573.6 Defect Information Report

V-08-03

Bulletin Number: **V-08-03**

SUBJECT: Loose Circuit Breaker Terminal Nuts and ECM Reprogramming

Circuit Breaker Terminal Nut Torque

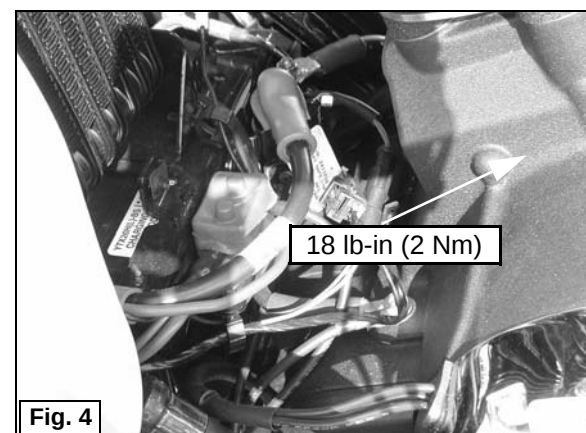
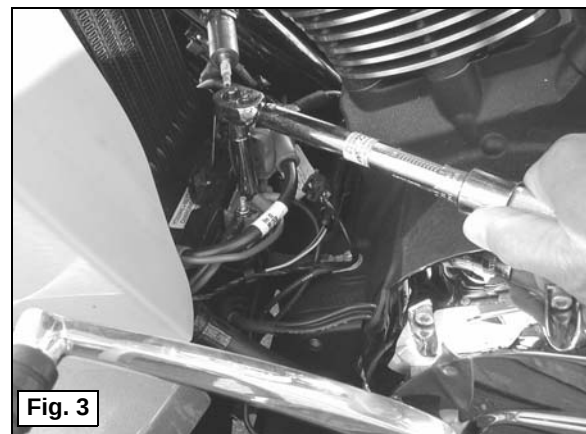
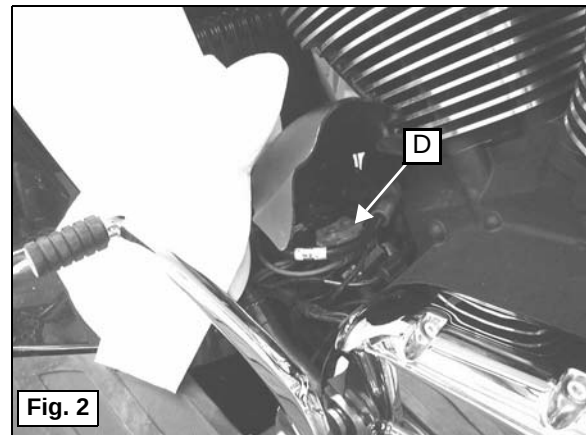
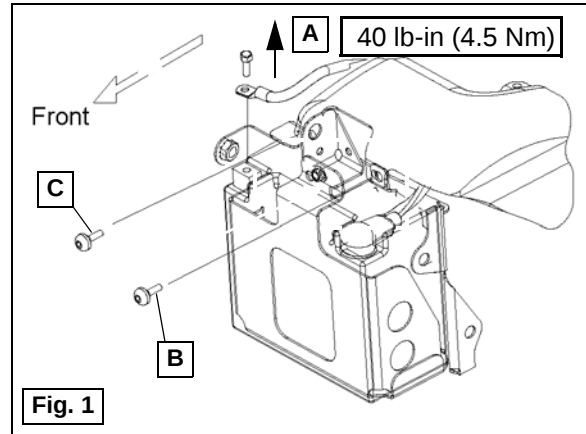
Overview: Tighten *both* circuit breaker terminal nuts to specified torque on all affected vehicles. Use a thin wall socket to ensure full engagement with the nut. Keep the socket at a 90 degree angle to the terminal stud when torquing the nuts.

1. Remove battery negative (-) cable (A). (Fig. 1)
2. Remove screw (B) from electrical cover (4mm internal hex). (Fig. 1)
3. Loosen screw (C).
4. Place a protective cloth between cover and lower leg fairing. Prop cover for access to circuit breaker (D). (Fig. 2)
5. Lift protective cover off circuit breaker.
6. Using a thin wall 3/8 inch deep socket, torque *BOTH* nuts to 25 lb-in (2.8 Nm). (Fig. 3)
7. Re-install protective cover securely over circuit breaker, pushing it firmly onto the studs. (Fig. 4)
8. Set electrical cover back in place and remove protective cloth.
9. Install screw. Torque both screws to x.x Nm (xx lb-in).
10. Install battery negative cable. Torque terminal bolt to 4.5 Nm (40 lb-in).
11. Perform reflash procedure following basic procedure outlined on page 5, and instructions within Digital Wrench.
